ZTE CORPORATION**Product Change Description**

[ZTE A2017U]

[Project Number:16ZTE027]

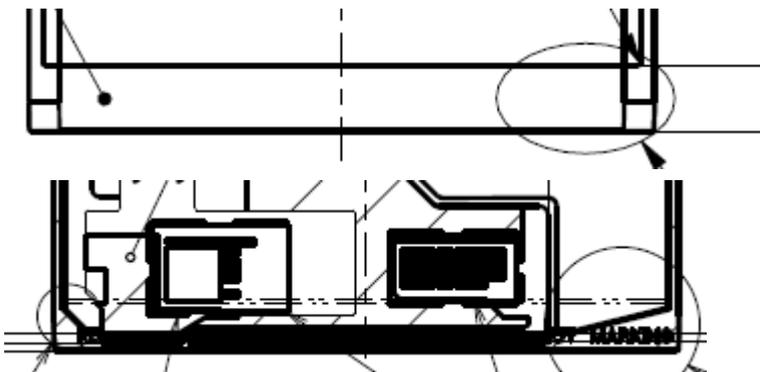
Antenna changes: GPS/WiFi/Bluetooth 3in1 antenna is now updated.

Aiming at improving GPS performance, we updated this antenna and this result to 1dB efficiency better than previous one. Meanwhile, WiFi/Bluetooth efficiency was slightly down.

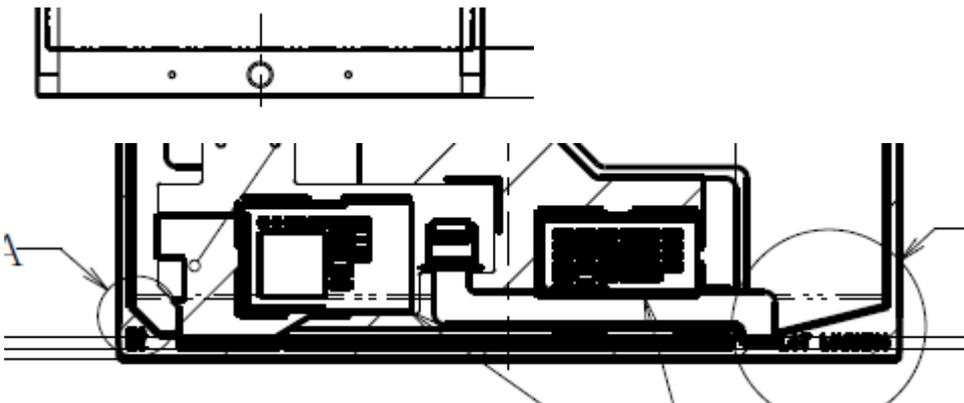
LCD changes: Yes, Added touch key and touch key FPC
